Request for Additional Information: Section 117(3) of the Maritime Area Planning Act 2021

Re: Uisce Eireann - Maritime Usage Licence Application Reference: MUL240048

Image 1: Source: Tailte Eireann Map Genie Premium ITM mapping

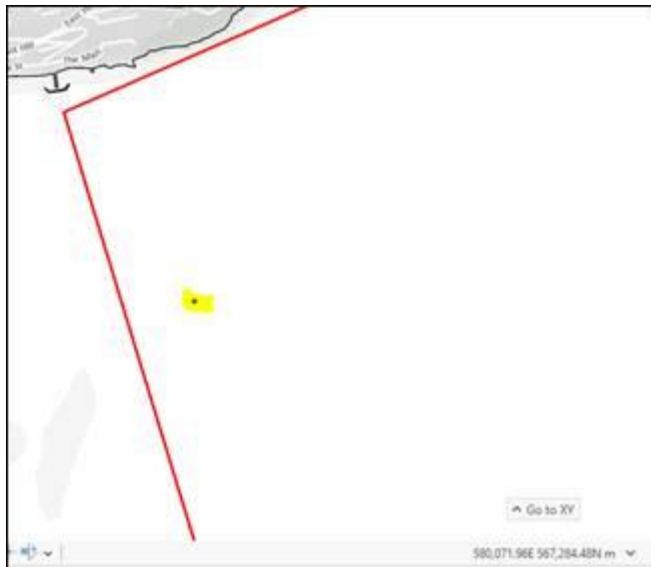
2. MARA also request the re-submission of GIS data and the supporting Proposed MUL Map. The GIS files submitted have an 'Area A, B & C' drawn, which correspond directly to the following Map Title: "OVERALL SITE LOCATION MAP". This map depicts the proposed locations for the deployment of nine Acoustic Doppler Current Profilers (ADCPs) within Cork Harbour. The applicant is requested to undertake the following:

- 2.1 Revise maps to ensure that the GIS shapefile represents the multiple areas included in the footprint of the maritime area that the development will occupy below the High-Water Mark as defined by the Chief Boundary Surveyor, excluding all islands, with correct individual area calculations (see Image 1):

- i. For MUL applications with multiple areas a single polygon shapefile with an attributed polygon for each area to be submitted, named sequentially, A, B, C etc.

- ii. Title the proposed MUL map accordingly: Label Multiple areas alphabetically, e.g. Area A, XXha, Area B, XXha etc.;
